SUGAR HILL | JOHN R & FOREST

MOSAIC HOMES

CHAD GOULD ARCHITECT LLC ©2019

August 28, 2021

SITE PLAN 1/20

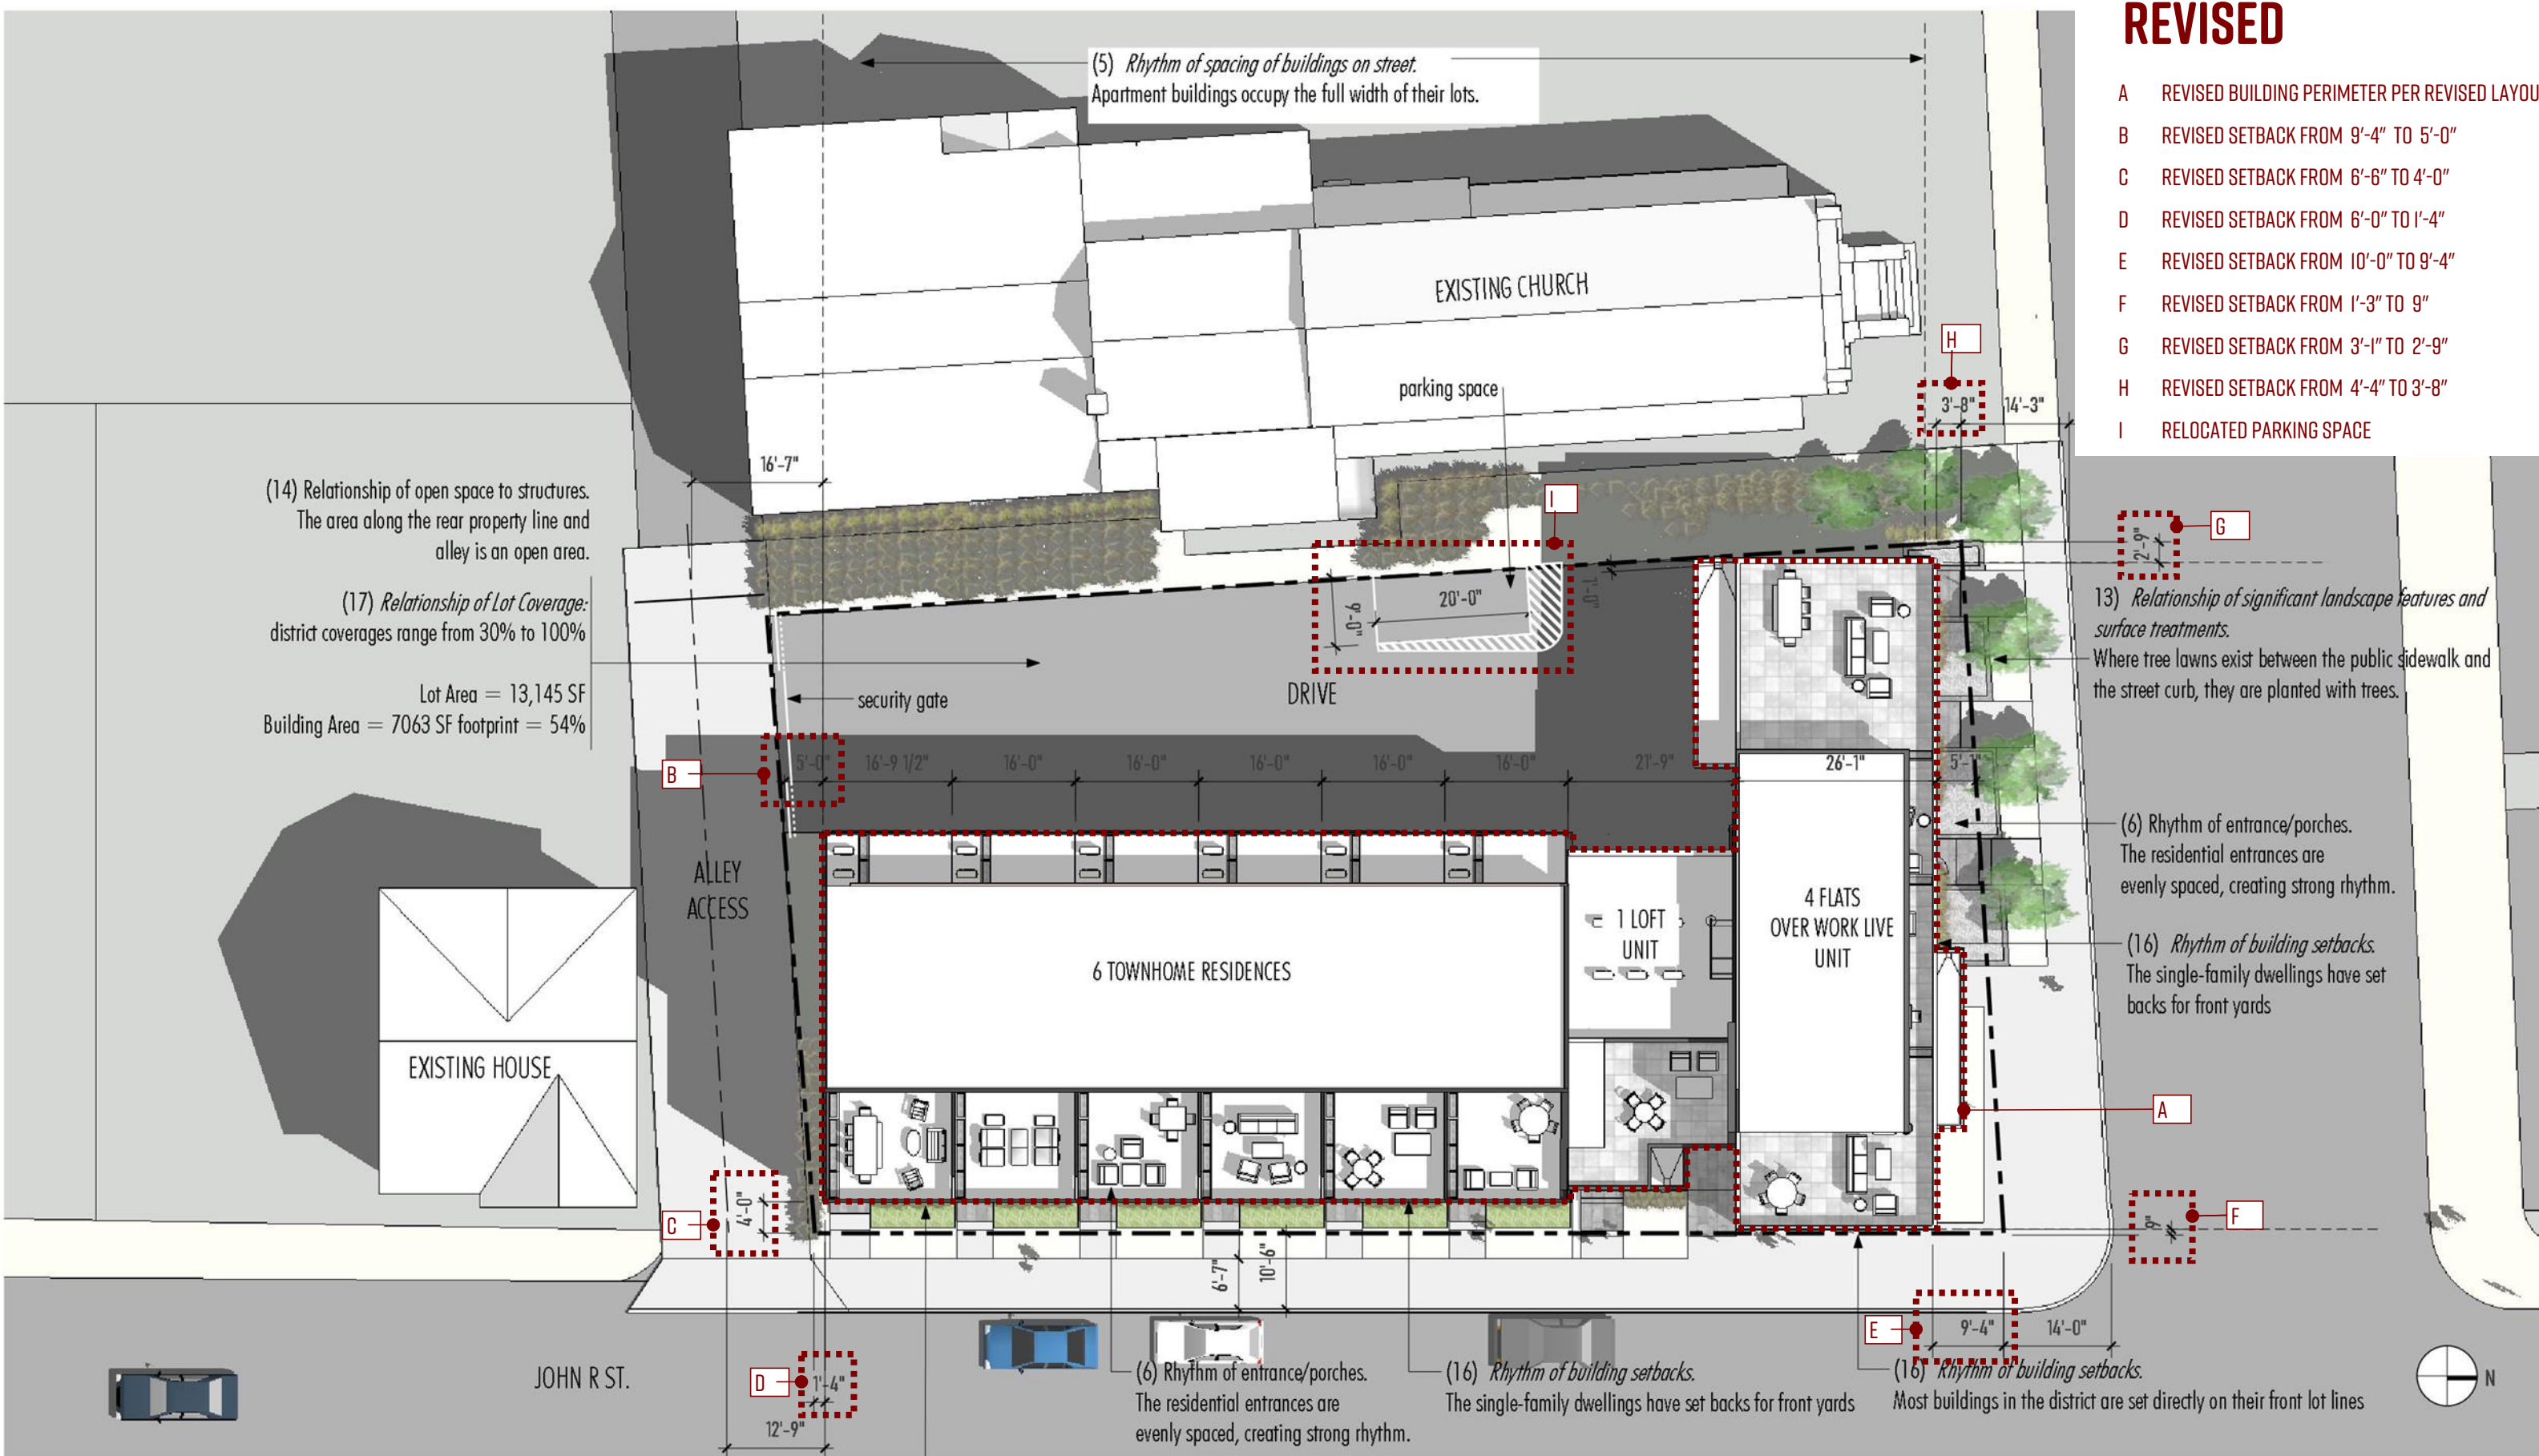
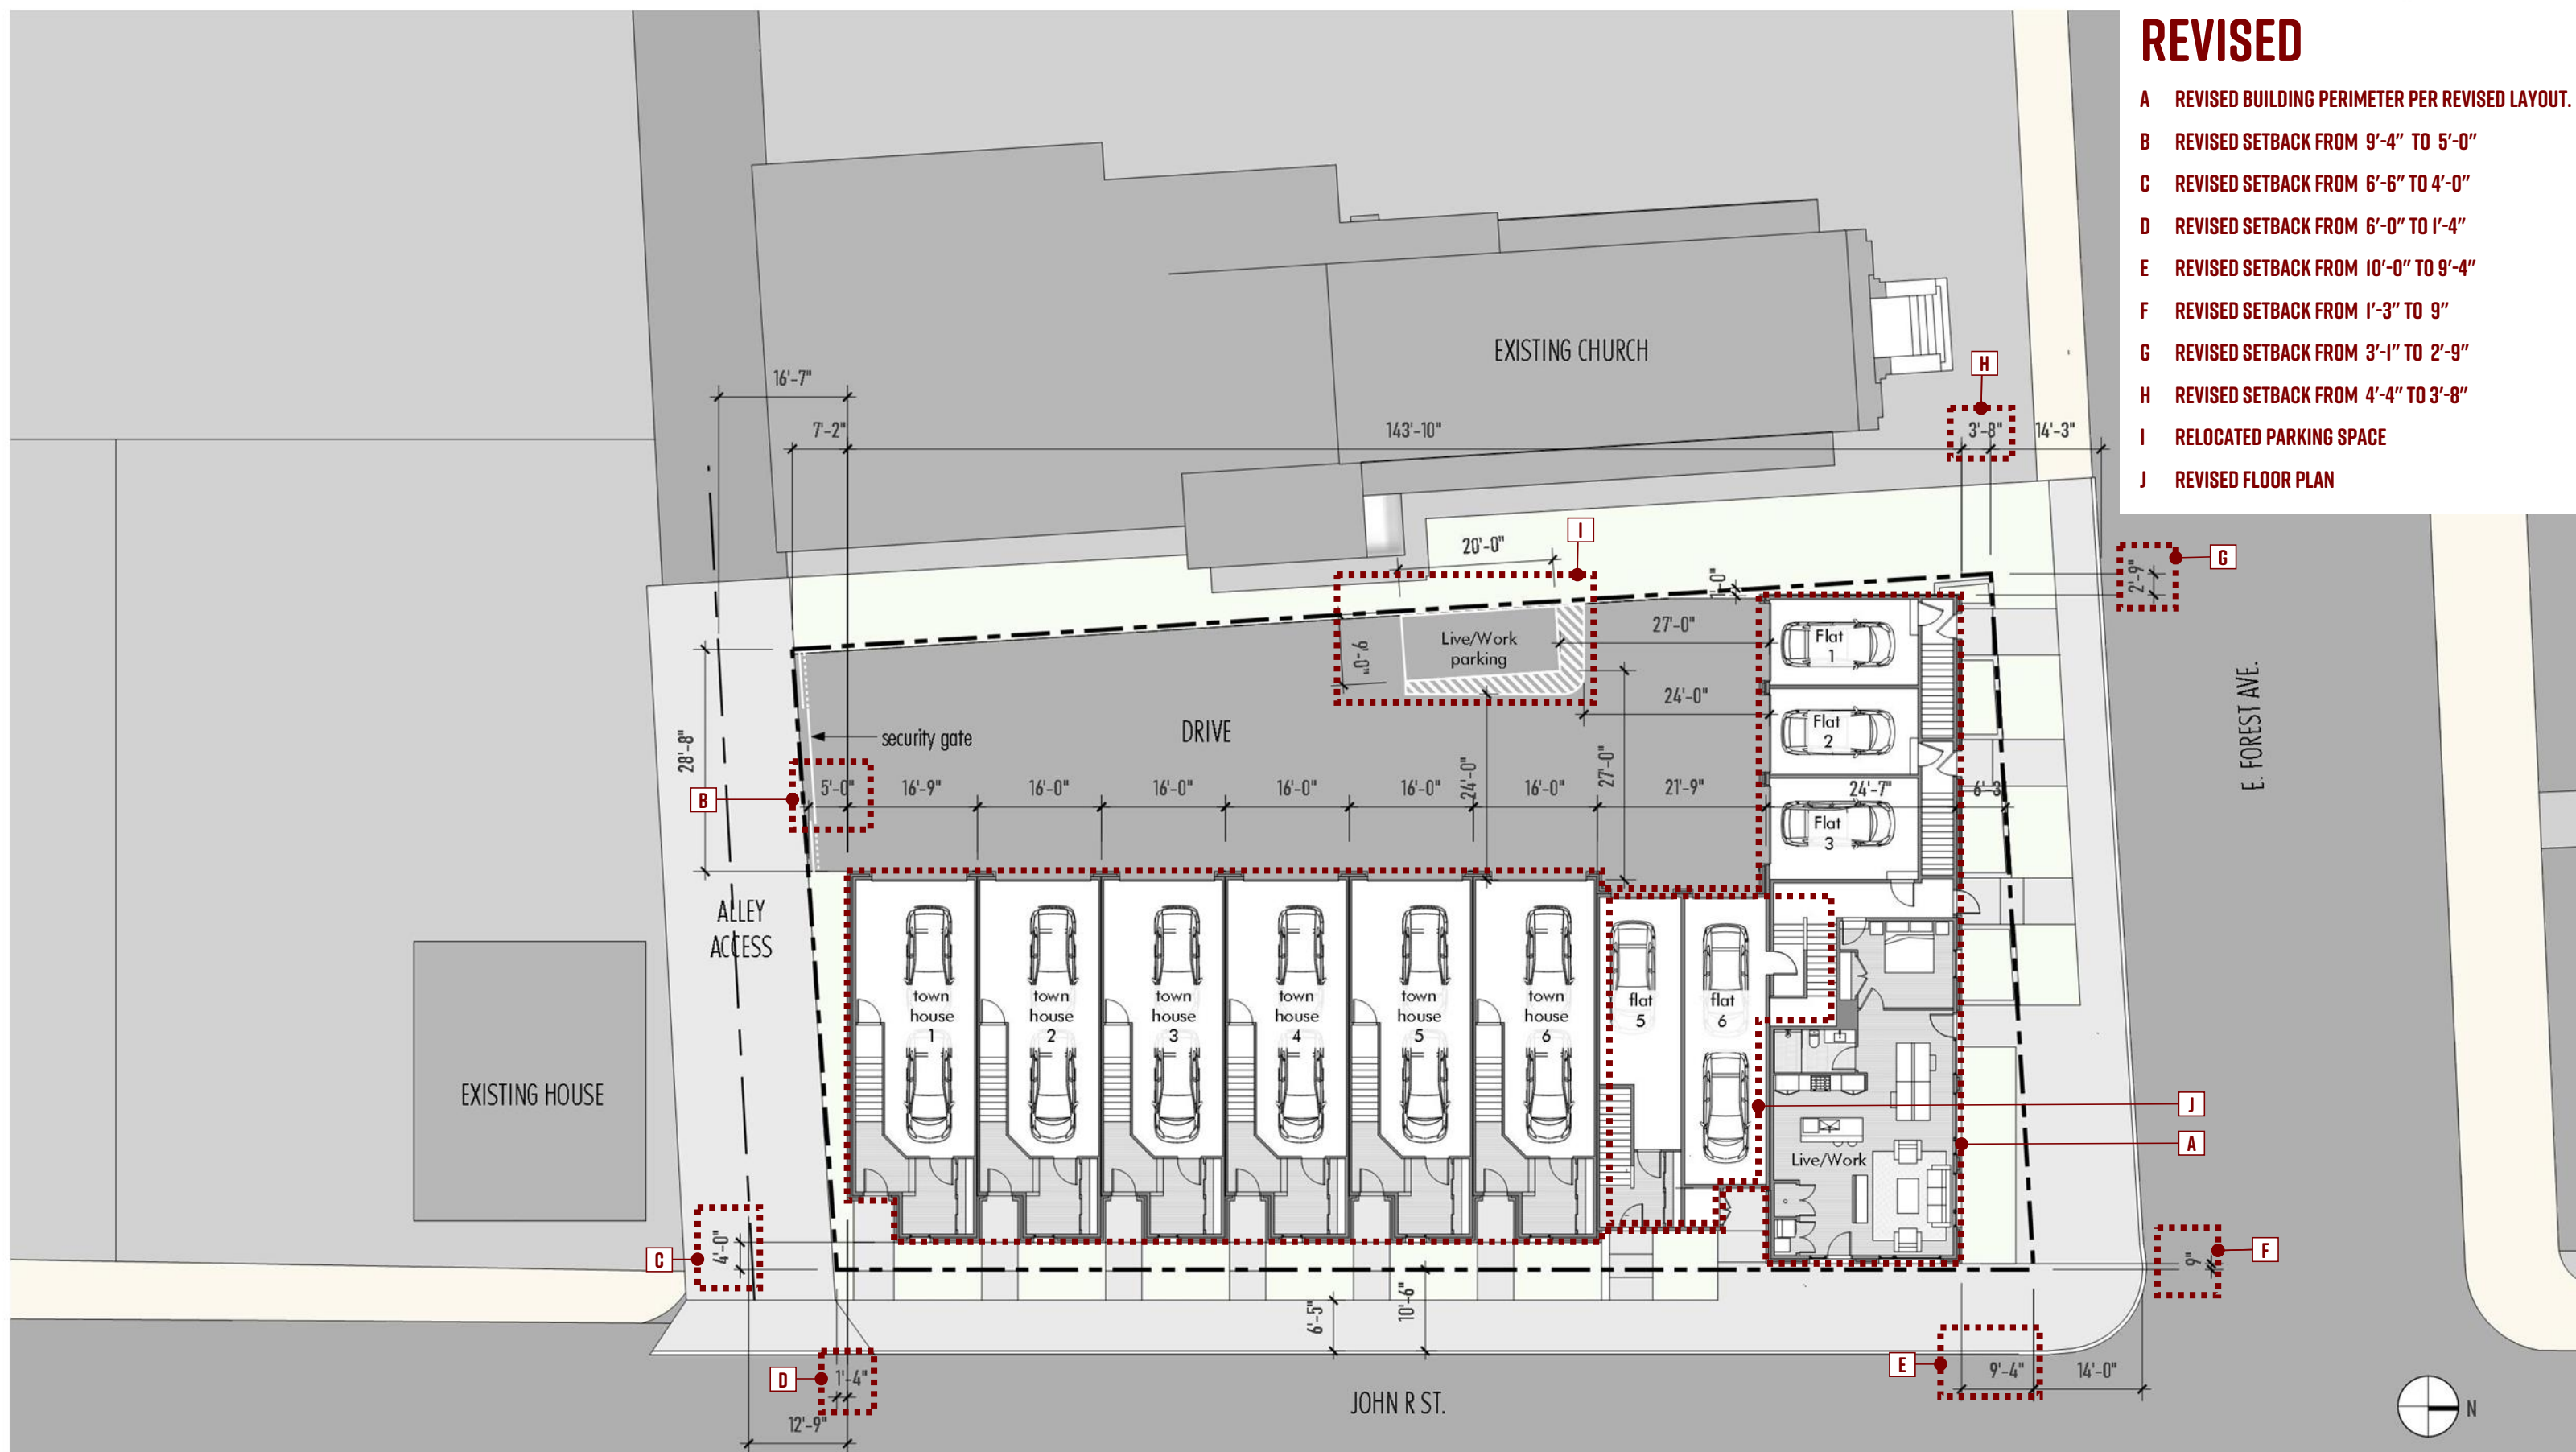
- A REVISED BUILDING PERIMETER PER REVISED LAYOUT.
- B REVISED SETBACK FROM 9'-4" TO 5'-0"
- C REVISED SETBACK FROM 6'-6" TO 4'-0"
- D REVISED SETBACK FROM 6'-0" TO 1'-4"
- E REVISED SETBACK FROM 10'-0" TO 9'-4"
- F REVISED SETBACK FROM 1'-3" TO 9"
- G REVISED SETBACK FROM 3'-1" TO 2'-9"
- H REVISED SETBACK FROM 4'-4" TO 3'-8"
- I RELOCATED PARKING SPACE

OVERALL THIRD FLOOR PLAN | 20'

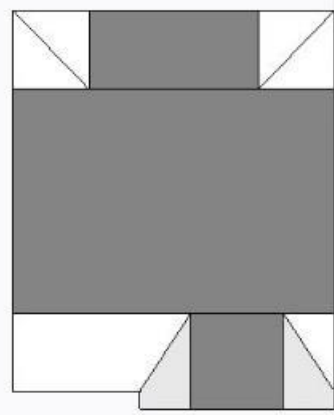
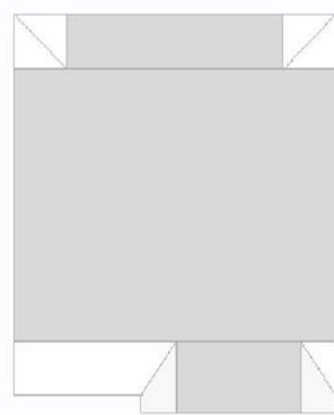
A REVISED FLOOR PLAN PER MARKET STUDY

OVERALL FOURTH FLOOR PLAN | 20'

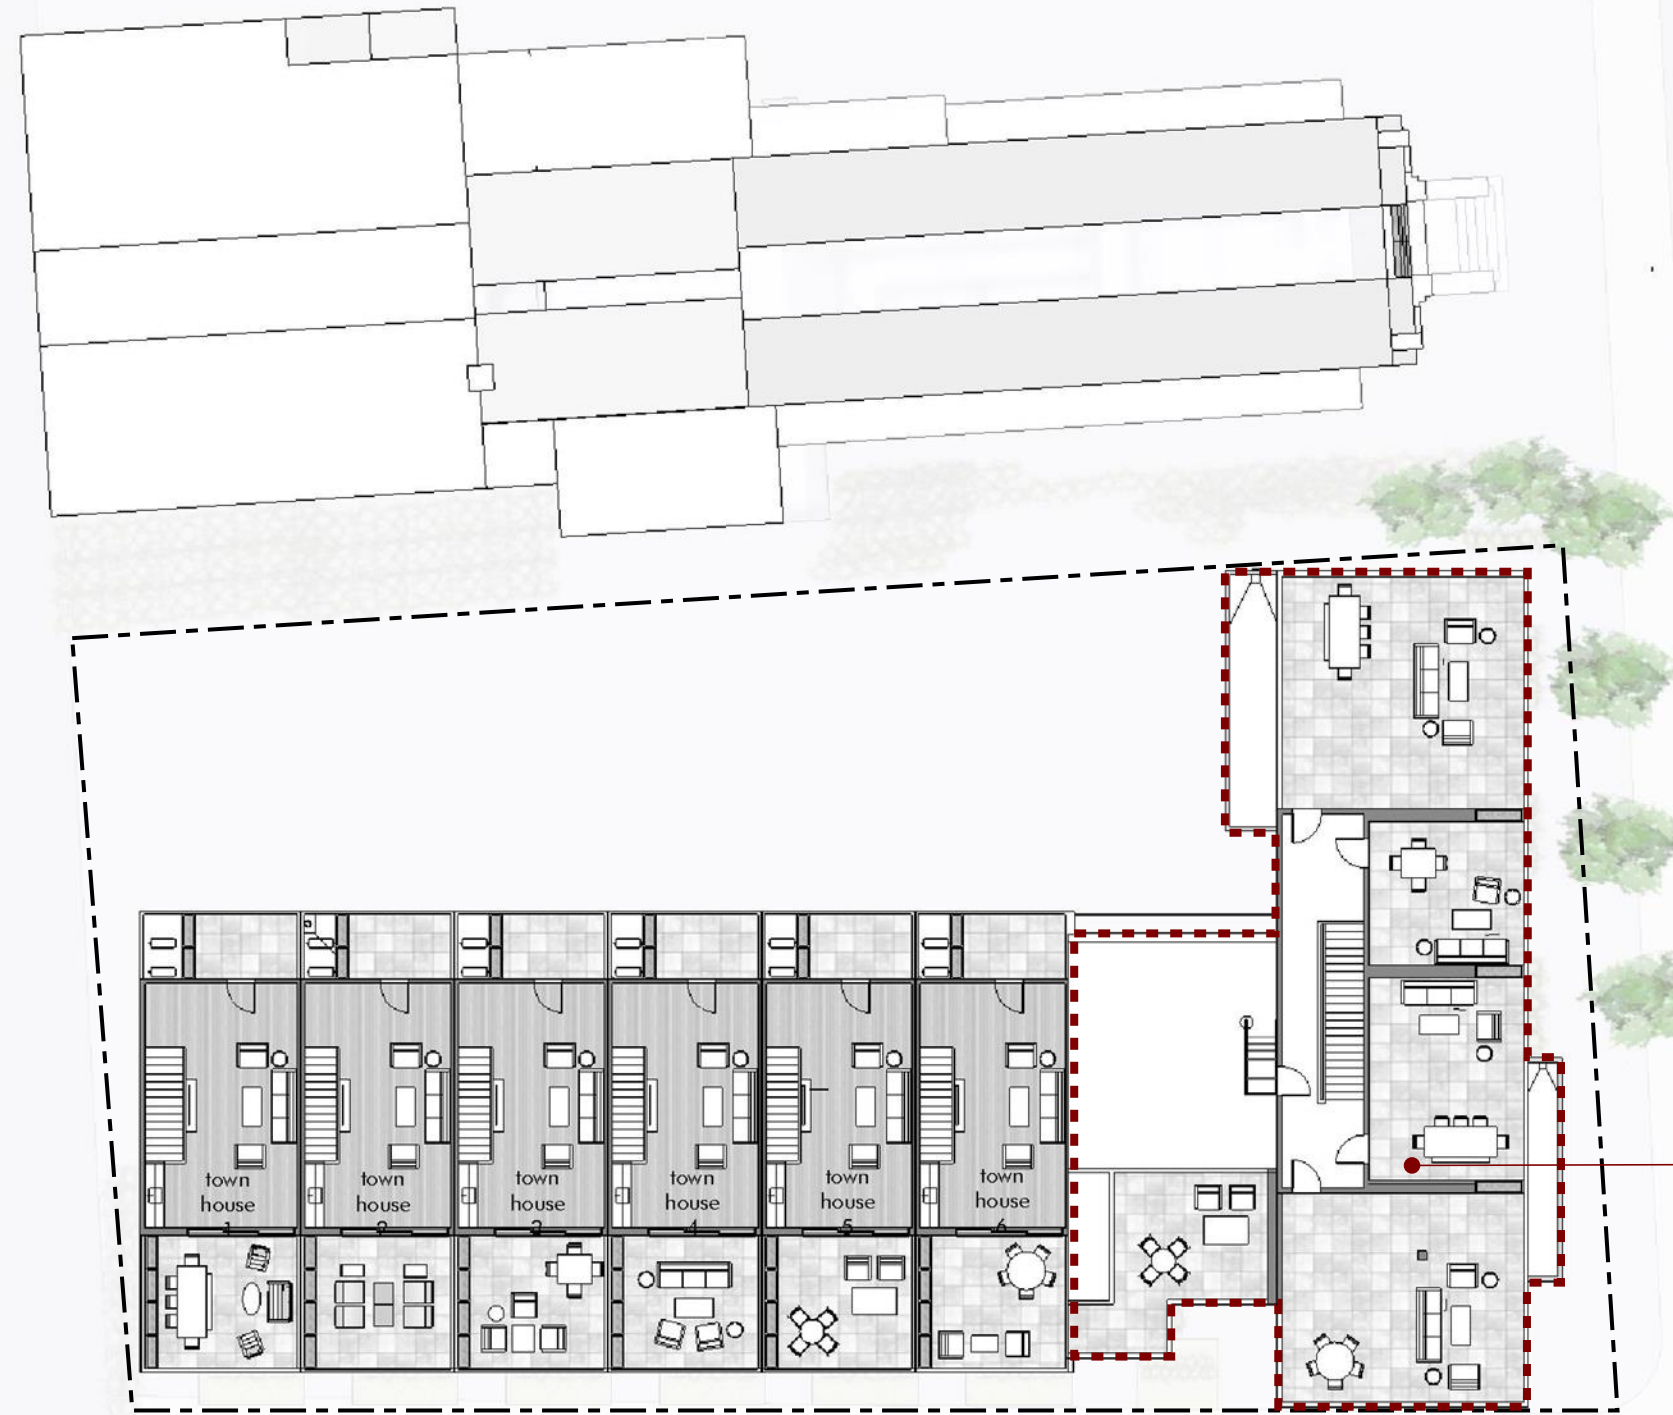
A REVISED FLOOR PLAN PER MARKET STUDY
